NUMBER: 08-017-13

Flash: Vehicle Theft Alarm Intermittently Sounds

2011 - 2012 (WK) Grand Cherokee (International only)

Fig. 1 Module and Tape Placement Location

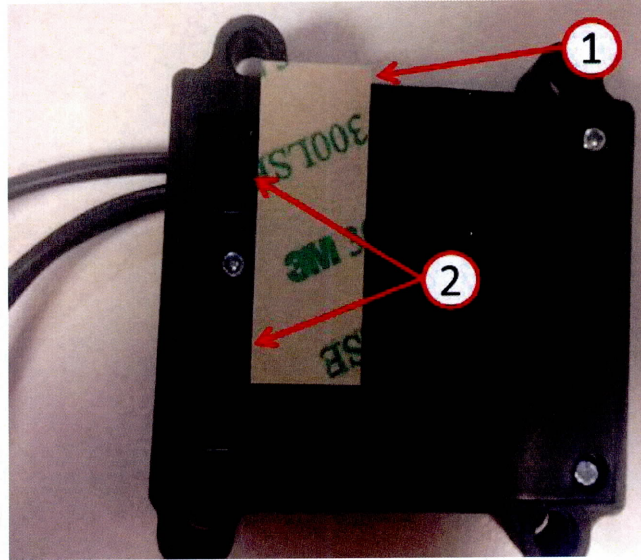
1. Reprogram the Intrusion module. Help using the wiTECH Diagnostic Application for flashing the Intrusion module is made available through the wiTECH Diagnostic Application. For instructions select the "HELP" tab on upper portion of the wiTECH window, then "HELP CONTENTS." This will open the Welcome to wiTECH Help screen where help topics can be selected.
2. Clear any DTC's that may have been set in other modules due to reprogramming. The wiTECH application will automatically present all DTCs after the flash and allow the tech to clear them.
3. Remove the overhead console to gain access to the Intrusion module. Follow procedures in TechCONNECT, 23 - Body / Interior / CONSOLE, Overhead, Front/Removal.
4. Lower the module and check if the back side of the module is clean were the tape is going to be placed, clean if necessary.
5. Apply the tape as shown in (Fig. 1).

- 1 - Leave a tab at this location.
- 2 - Line up the tape along these indents.

NOTE: There are 2 pieces of tape in the package. Only one piece of tape is needed, the 2nd piece of tape is used as a back up.

- 6. Reinstall the module, putting slight pressure on the module to seat the tape.
- 7. Install the overhead console, follow procedure in TechCIONNECT, 23 - Body/Interior/CONSOLE, Overhead/Installation.
